Natural Environment Checklist

Project Name: SPAR Booster Pump Station

Permit Number(s): PRJ15-00036, ASDP19-00001, SEP19-00006

Project Description: Construction of a drinking water booster pump station (BPS) and approximately 8,000 linear feet of water-related transmission lines (pipelines) within the City of Issaquah just north of Interstate 90 (I-90).

G11

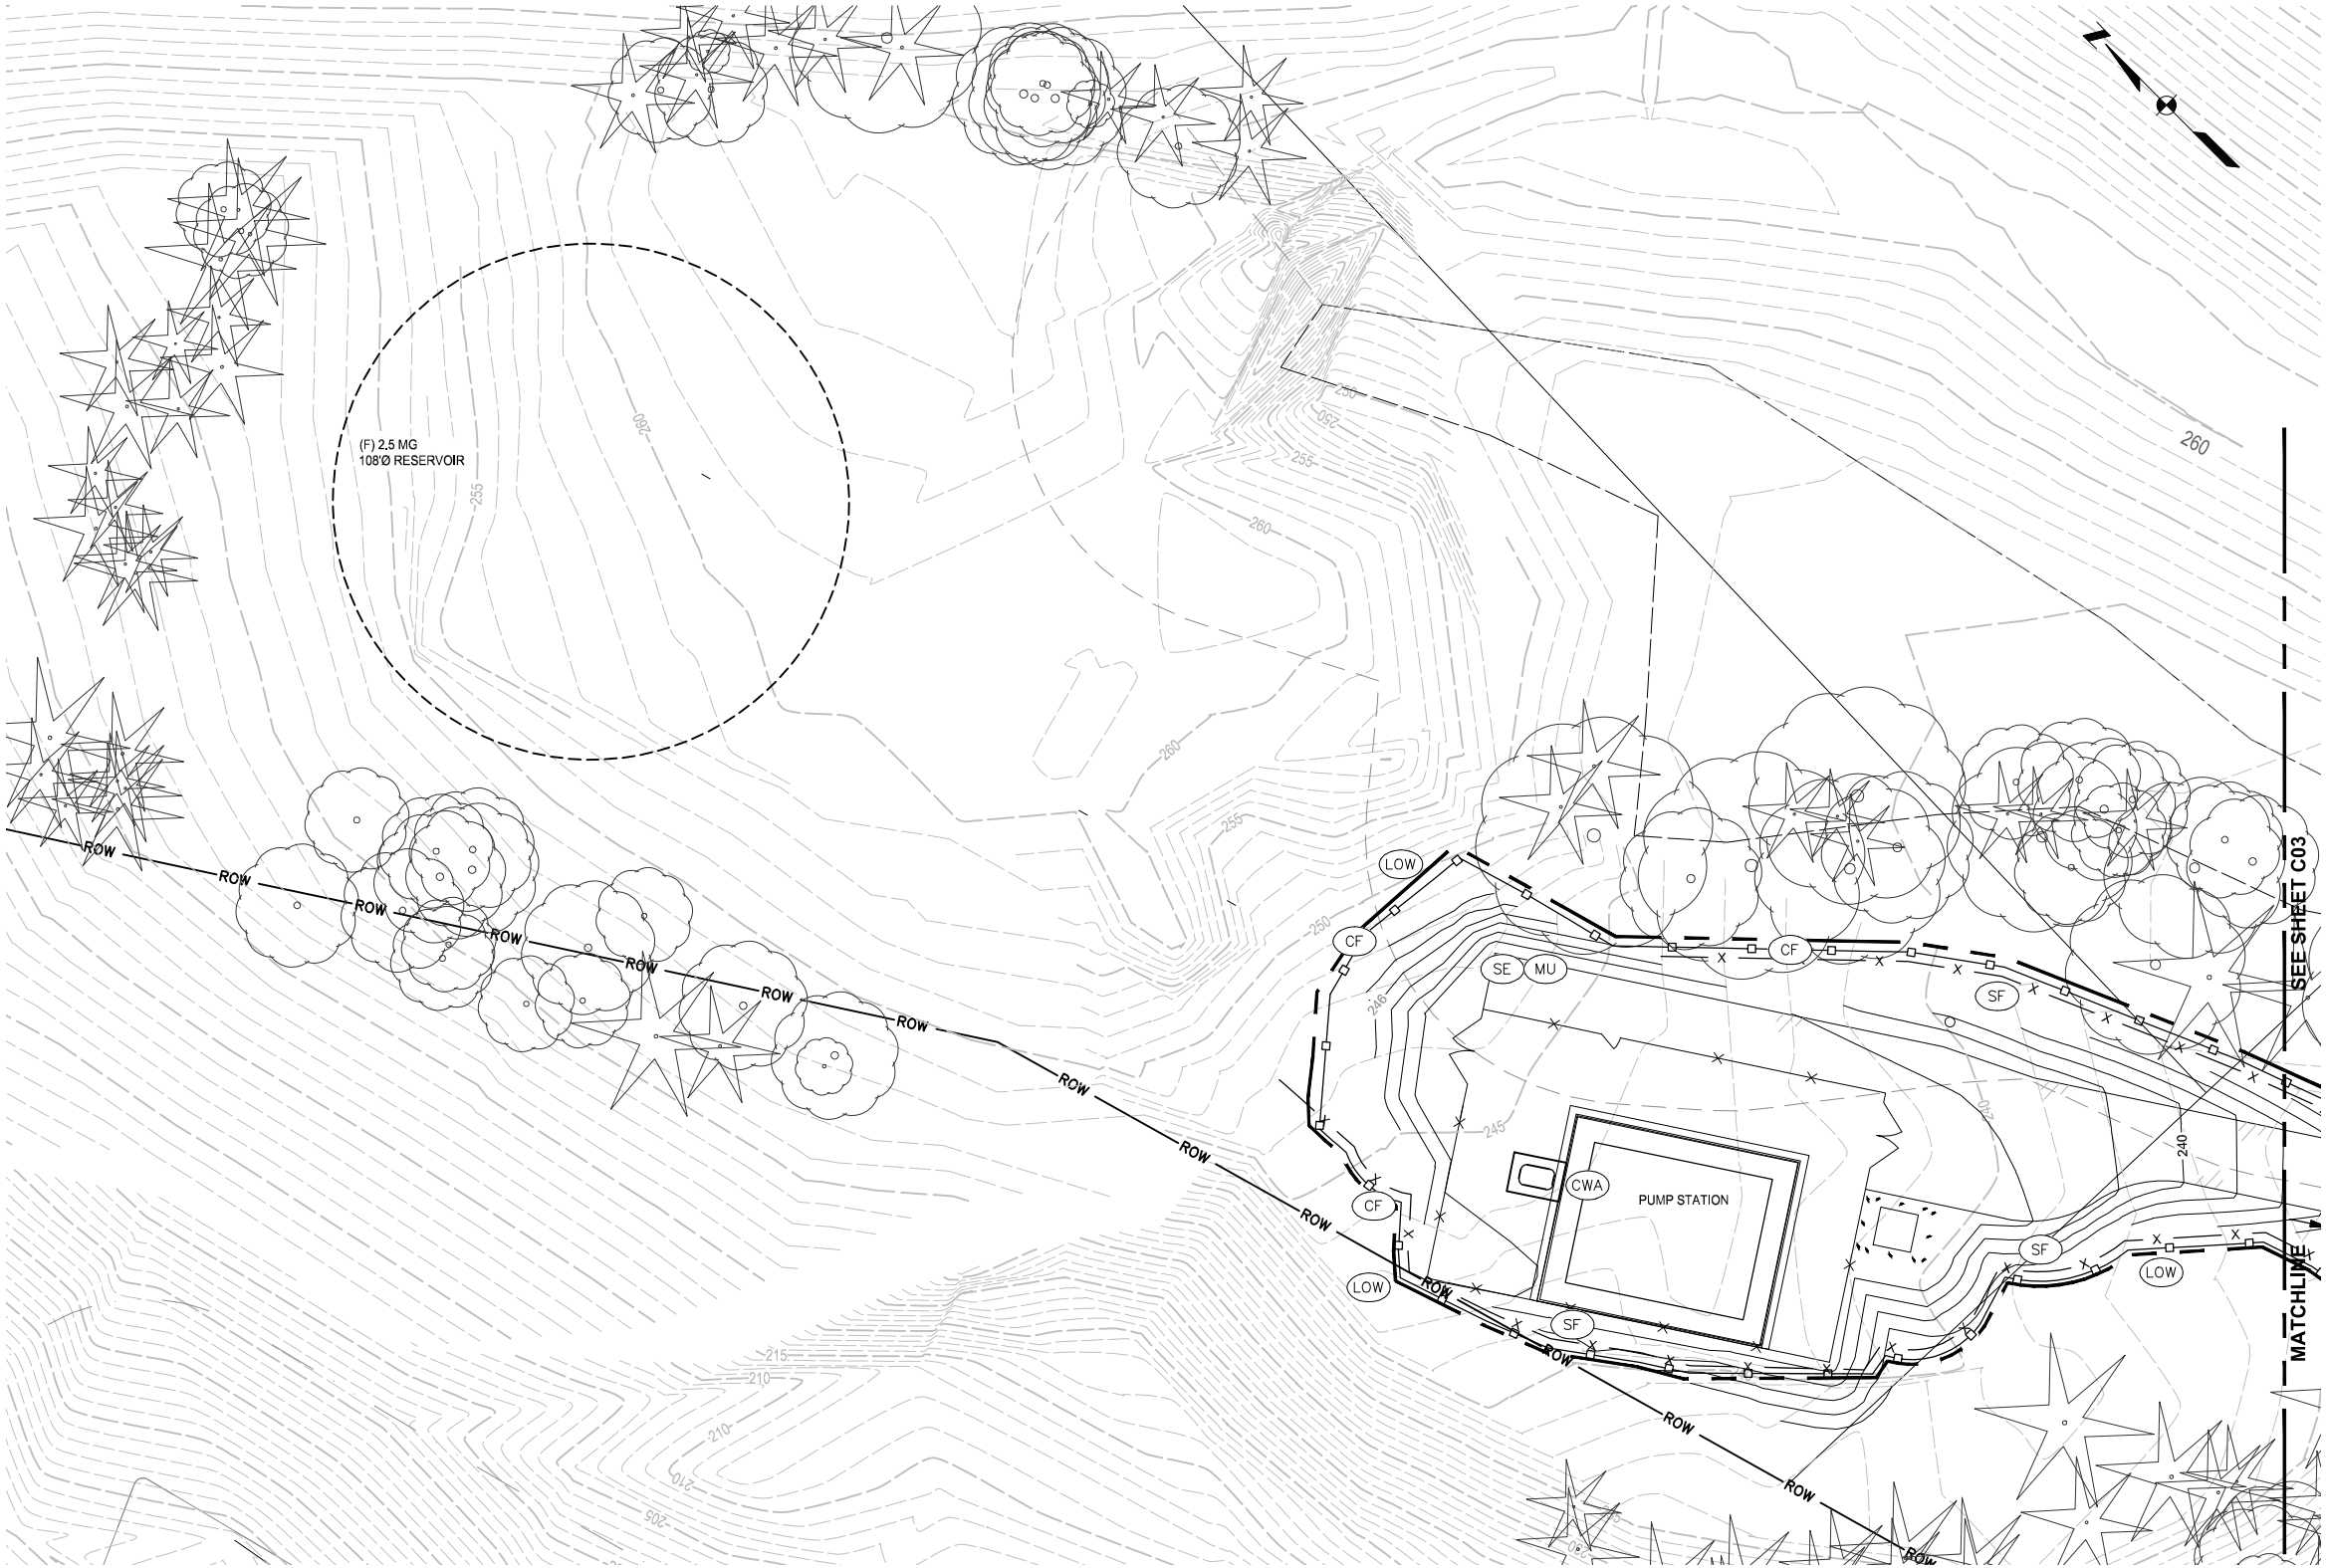
8. There is no map that clearly shows the steep slopes as they correlate with the wetland and stream buffers.

5. City code for Steep slope and Landslide hazard areas do not allow removal of vegetation within the steep slope/ landslide hazard area buffers. It is unclear from the information provided that significant trees are not being removed from within the buffer. Please clearly show that no native vegetation is being removed from the buffer.

Plan Sheet G11 shows the regulated steep slopes while Sheet L1 indicates the streams,

wetlands, and associated buffers. Only Wetland A is located on a steep slope and neither the wetland, nor its buffer, will be impacted by the project.

No significant trees will be removed from the steep slope area (see sheet G11 of the plan set). Although a few individual trees within the buffer may be removed, such trees

will not alter slope stability and will be fully mitigated for at a ratio of greater than 8:1 (see CAR).
